TE's SW Path lighting proposal: -violates WisDOT guidelines -would *reduce* safety of SW Path users

Perry Sandstrom BSEE

Daily (and often nightly) Southwest Path biker & runner
11/25/12 - Southwest Path Alliance - Facebook/owlpath

Figure 1. Current Overhead LED Proposal

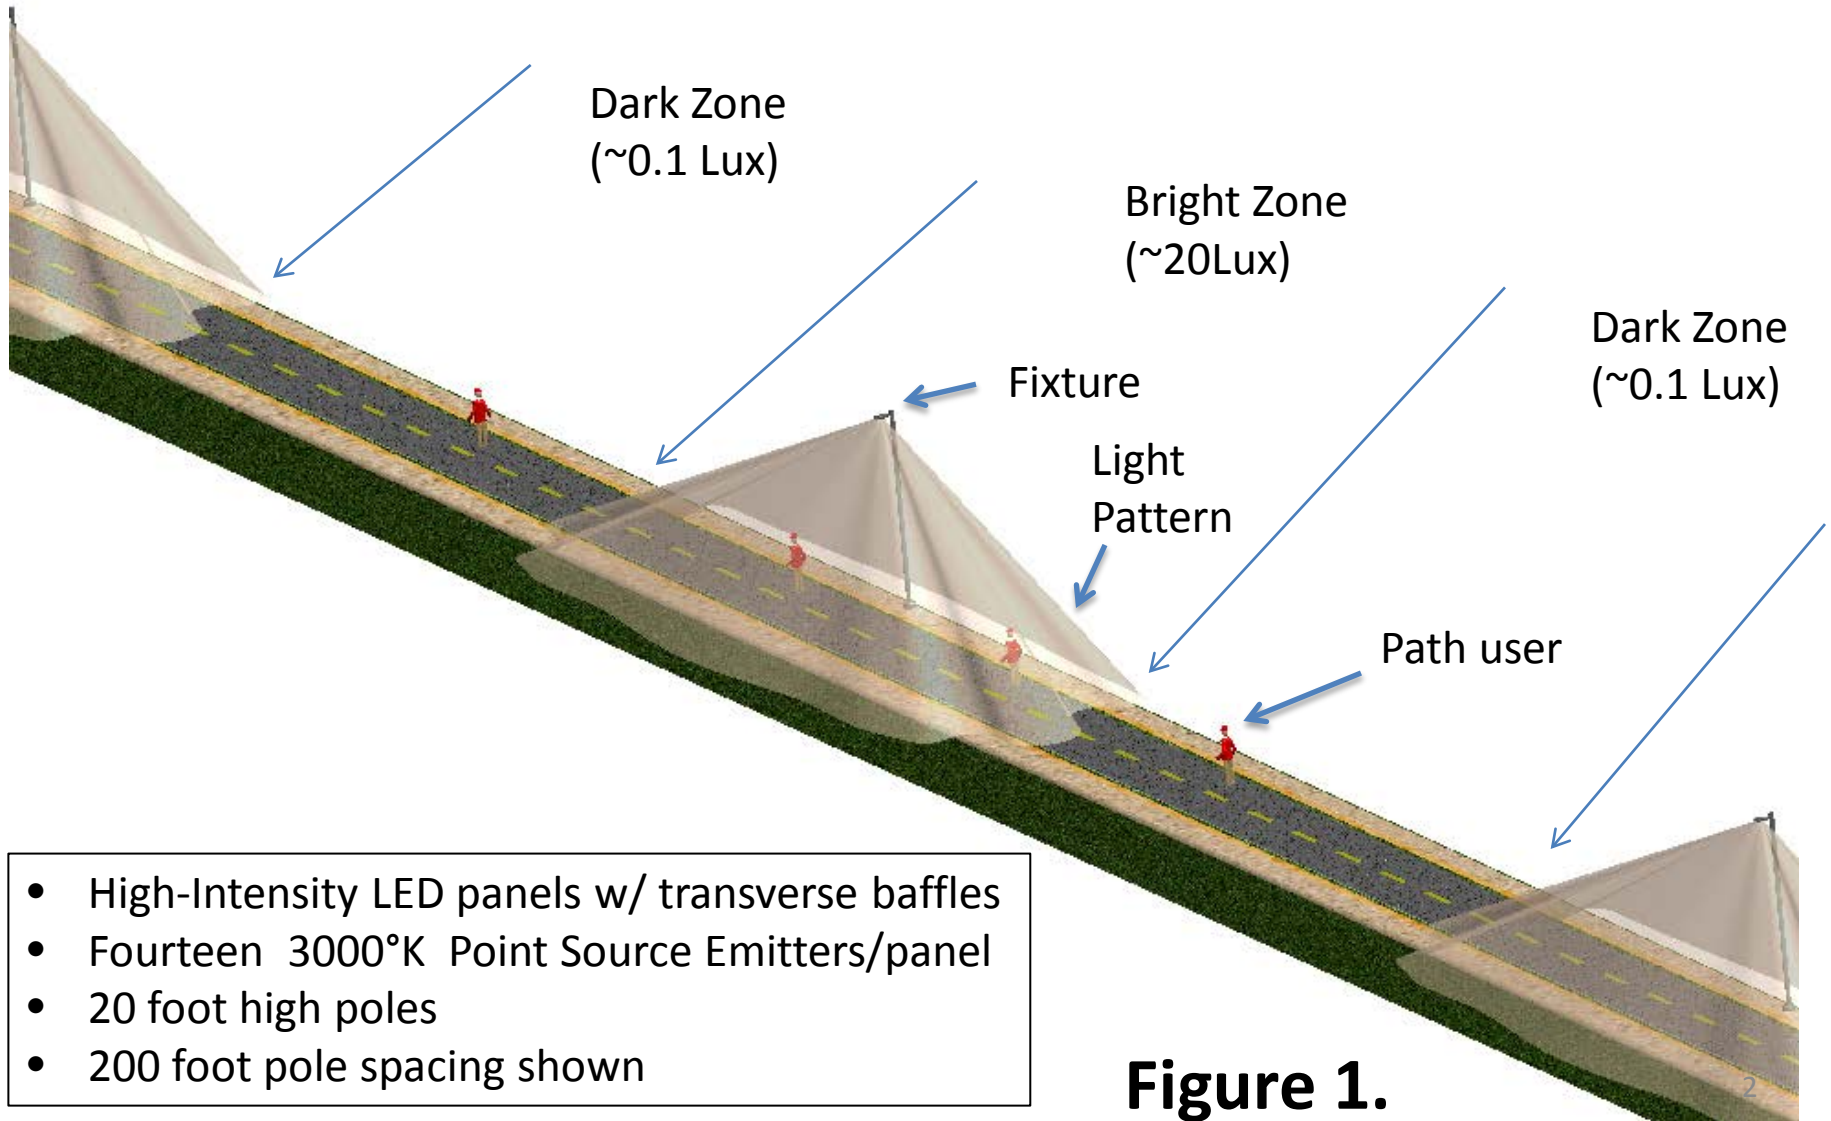
Project does not meet WisDot Guidelines for uniformity

Figure 2.

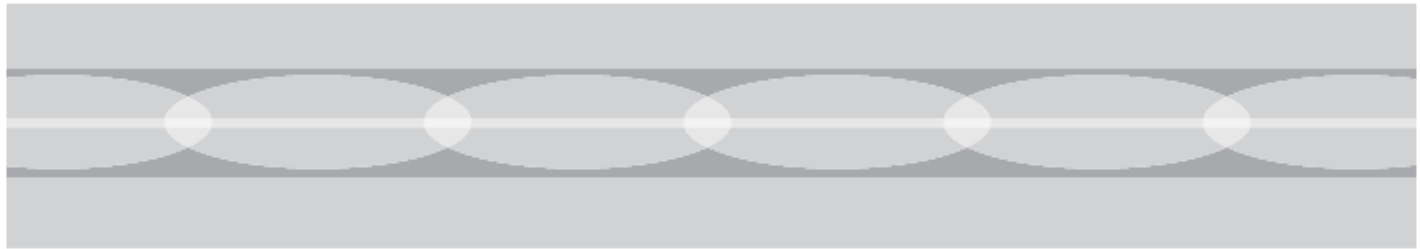
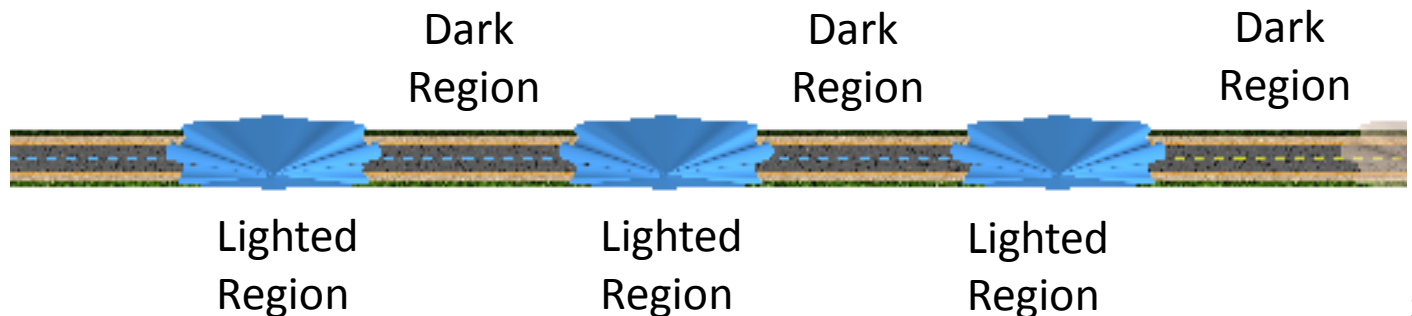
“Figure 4-53: Properly spaced luminaires overlap
To provide a more constant visual environment”

WisDot
Handbook:
(overlap)

Proposal:
(no overlap)

Figure 3.

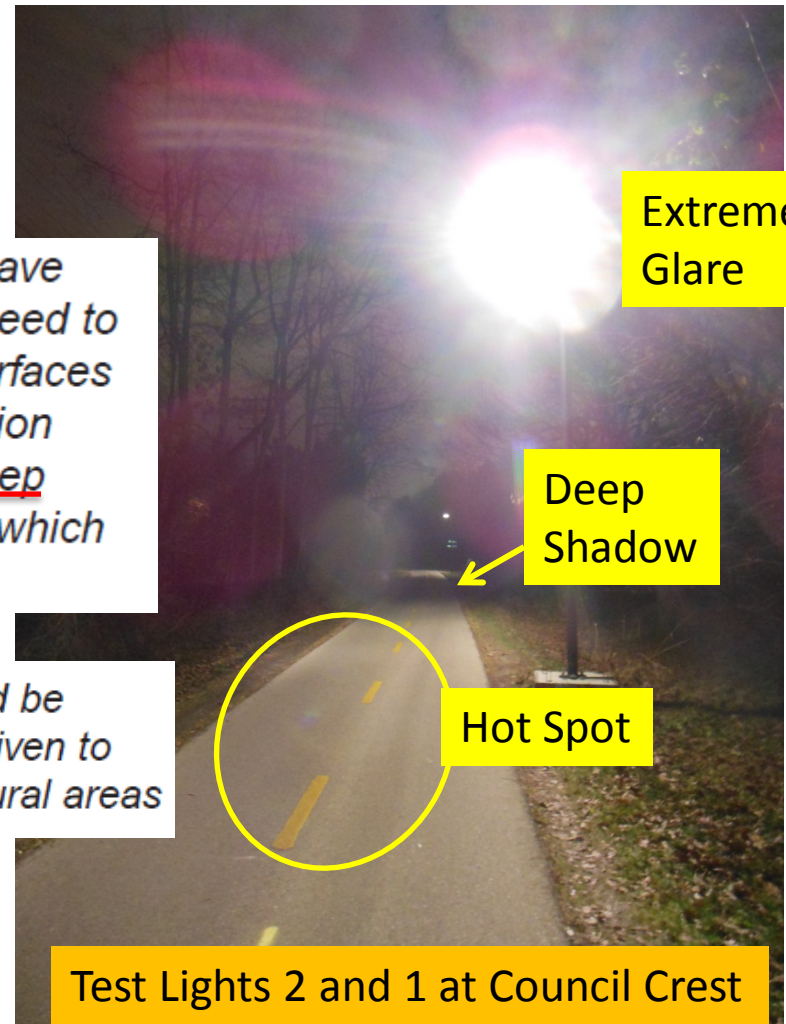
Project Violates WisDOT Guidelines for path vision and glare

- **Night vision:** Both bicyclists and pedestrians have specific requirements for nighttime seeing. Both need to see small obstacles and changes in pavement surfaces to feel safe using paths at night. Uniform illumination should be provided that avoids “hot spots” and deep shadows, and care must be taken to avoid glare, which can compromise night vision.

- **Full cutoff:** Glare from cobra-style luminaires should be avoided in all cases. Particular attention should be given to pathways adjacent to residences, waterways, or natural areas

(these LED Fixtures are *higher* glare than cobras)

Extreme
Glare

Deep
Shadow

Hot Spot

Figure 4.

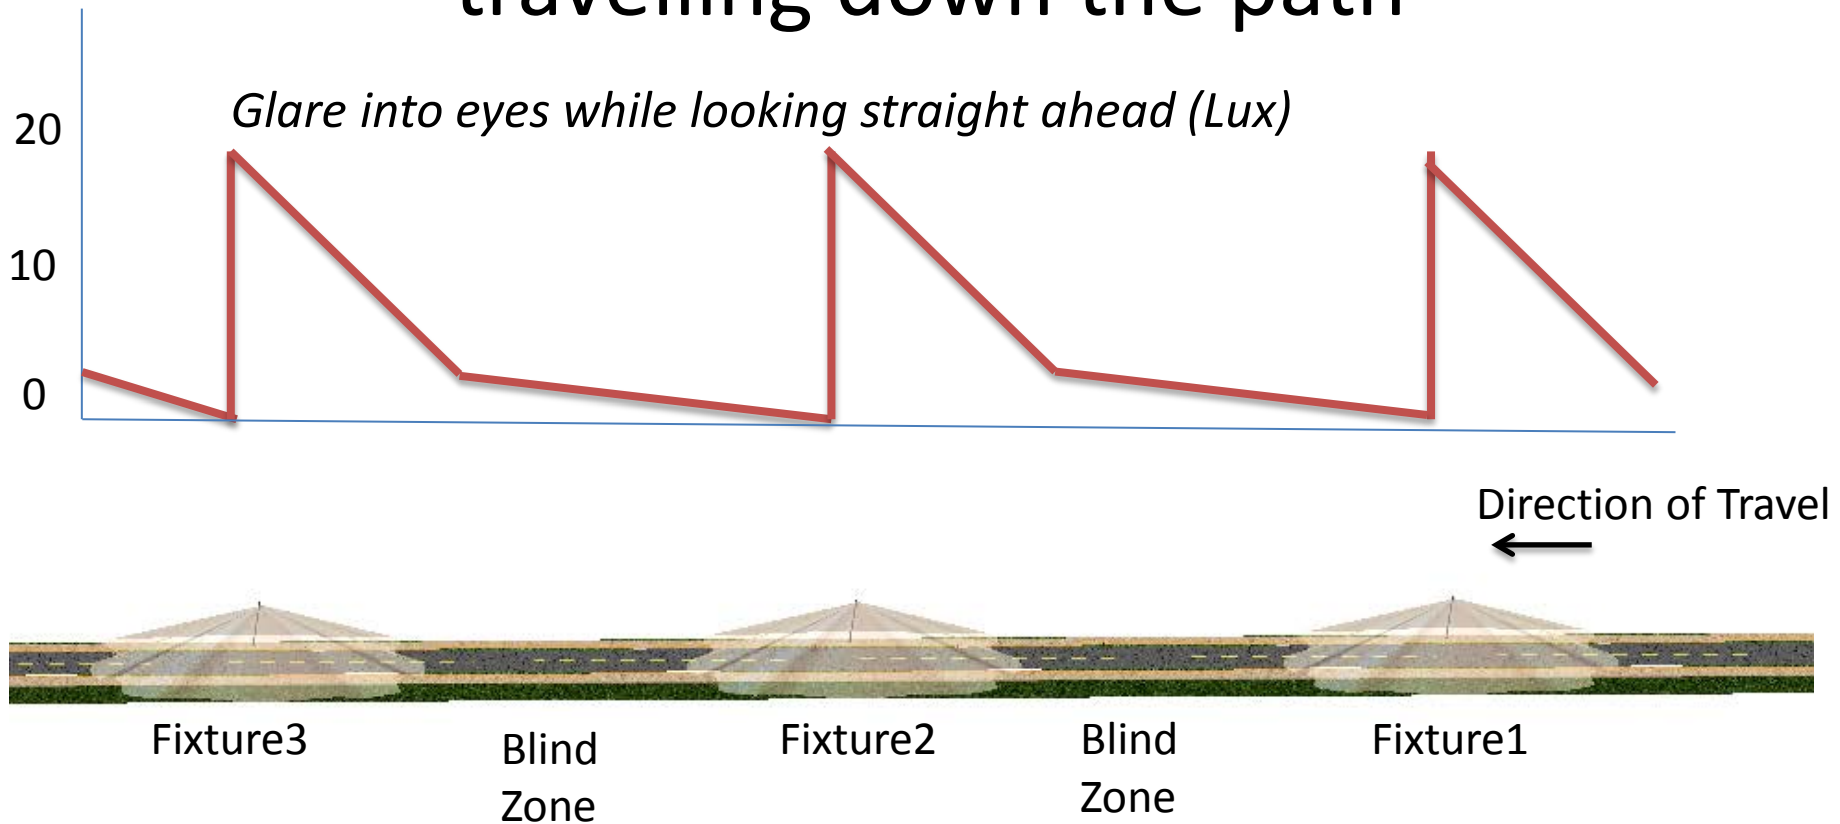
Causes “Saw-tooth” Eye Adaptation while travelling down the path

Wide variation causes fatigue and overall reduction in visual acuity.
Limited on streets by higher poles, closer spacing, type1 fixtures and car roofs.

Figure 6.

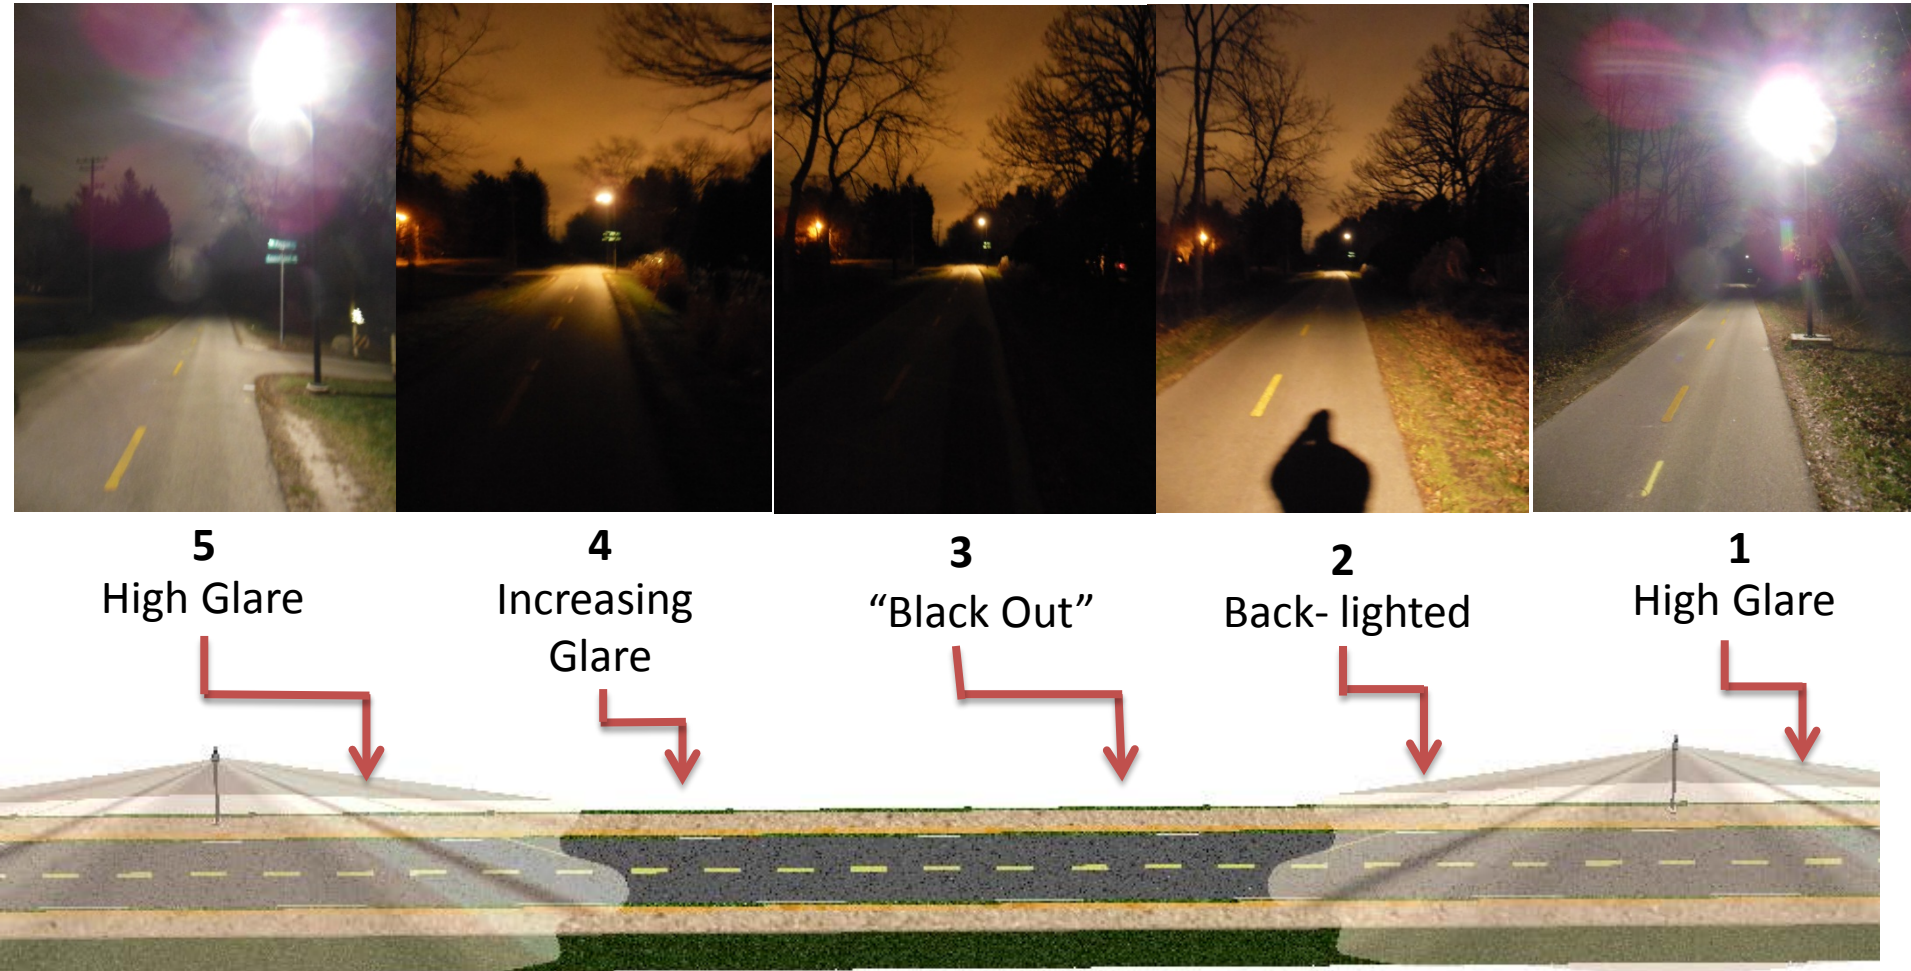
Project will Introduce a Known Visibility Hazard

Path user (A) is difficult for Path User (B) to see because of Loss of B's dark-adaptation from glare and A's relative darkness

Moving through transitions

Council Crest Test Light Pair; Walking NE
